Contract #: 04-0120F4Cty: SF/ALA Rte: 80 PM: 13.2/13.9File #: 69.25B**QUALITY ASSURANCE -- NON-CONFORMANCE REPORT****Location:** Changxing Island, Shanghai, China**Report No:** NCR-000806**Prime Contractor:** American Bridge/Fluor Enterprises, a JV**Date:** 17-Jul-2010**Submitting Contractor:** Zhenhua Port Machinery Company, Ltd (ZPMC), Changxing Island**NCR #:** ZPMC-0768**Type of problem:**

Reference Description: Critical Weld Repair (SPCM) without Prior Approval from Engineer**Description of Non-Conformance:**

To: AMERICAN BRIDGE/FLUOR, A JV **Date:** 19-Jul-2010
 375 BURMA ROAD
 OAKLAND CA 95607 **Contract No:** 04-0120F4
 04-SF-80-13.2 / 13.9
Dear: Mr. Charles Kanapicki **Job Name:** SAS Superstructure
Attention: Mr. Thomas Nilsson Project/Fabrication Manager **Document No:** 05.03.06-000762
Subject: NCR No. ZPMC-0768

Subject: NCR No. ZPMC-0768

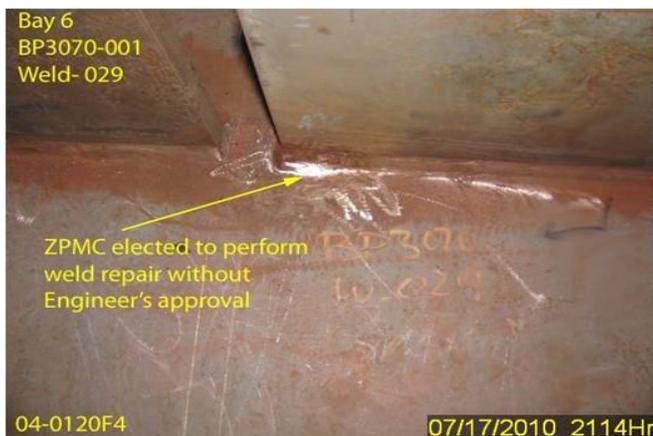
- Weld metal / base metal crack repair performed on Seismic Performance Critical Member (SPCM) without prior Engineer's approval.
 - The repair was performed on fillet weld identified as BP3070-001-029.
 - This weld was previously tested and rejected by Caltrans (CT) QA.
 - The indication was confirmed as a crack using the Magnetic particle Testing (MT) method.
 - ZPMC workers removed a portion of the weld and ground approximately 4mm into the SPCM bottom plate to remove the crack entirely.
 - The weld is a fillet weld T-joint, joining stiffener identified as RS3415M to SPCM bottom plate identified as PL3380A.
 - The repair area is approximately 10mm from the east end of the stiffener (nearest to PP124).
- For further information, please see the attached picture below.

AWS D1.5 2002, Section 12.17.4: Except as provided in 12.17.2, all welded repairs shall be considered critical.

AWS D1.5 Sec 12 par. 12.17.4: All critical weld repairs to base metal and welds shall be approved by the Engineer prior to beginning the repair and shall be documented giving details of the type of discontinuity and extent of repair.

Reference Resolution: ZPMC has repaired the base metal indication in accordance with the approved CWR and is providing NDT after repair to show it is acceptable.

The proposed resolution is acceptable. This NCR is considered closed.
